Wisconsin Department of Transportation

Proposal #19: 1590-14-74
Bradley – Rhinelander
Gatewood Heights Rd to N Rifle Rd
USH 8
Oneida County

This is Addendum No. 02, which provides for the following:

PROJECT NO: 1590-14-74		HWY: USH 8		COUNTY: ONEIDA		TYPICAL SECTIONS		SHEET 8		WISDOT/CADDS SHEET 42	
FILE NAME: P:\500X\5609.DP\23\USH8.ONE\CA0501474\SHETS\020801-75.DWG		PLOT DATE: 9/9/2006 9:49 AM		PLOT BY: AUSTIN STRAHL		PLOT SCALE: 1 IN=10 FT					
LAYOUT NAME: 05

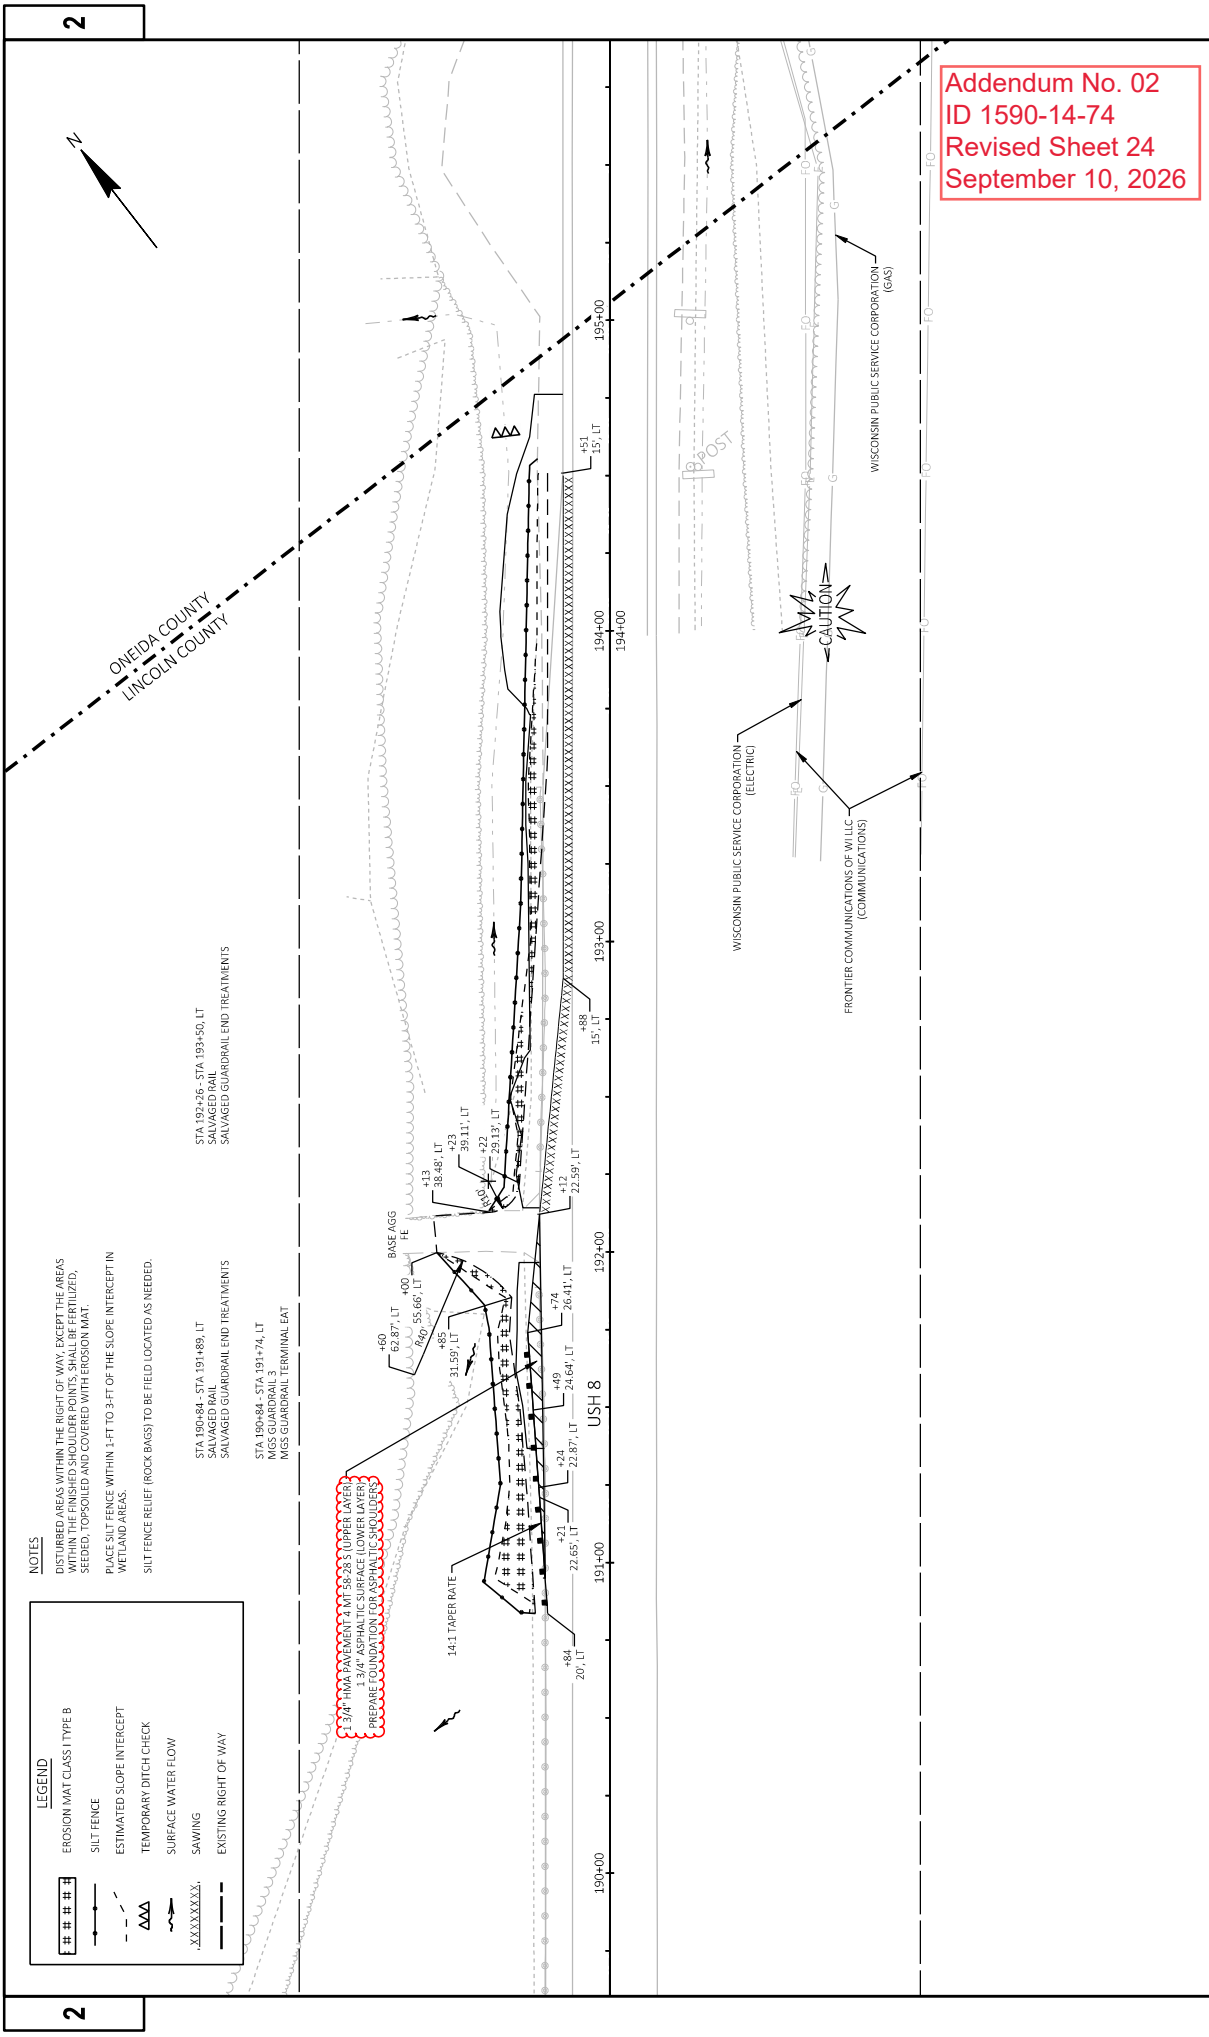
Revised Plan Sheets	
Plan Sheet	Plan Sheet Title (brief description of changes to sheet)
8	Adjusted the notes to change the lower layer of guardrail widening to asphaltic surface.
24	Adjusted the label to change the lower layer of guardrail widening to asphaltic surface.
74	Adjusted the quantities of HMA Pavement 4 MT 58-28 S and Asphaltic Surface.
75	Adjusted the lower layer of guardrail widening to Asphaltic Surface and changed the mixture and density acceptance for the lower layer.

SEE CONSTRUCTION DETAILS FOR LOCATIONS OF PROPOSED GUARDRAIL WHERE THE PROPOSED PAVED SHOULDER IS WIDER THAN EXISTING PAVED SHOULDERS USE THE ITEM PREPARE FOUNDATION FOR ASPHALTIC SHOULDERS AND PLACE AN ADDITIONAL 1.34" ASPHALTIC SURFACE LOWER LAYER. SHOULDER GROSS SLOPE MAY VARY AT GUARDRAIL. SEE CROSS SECTIONS FOR ADDITIONAL INFORMATION.
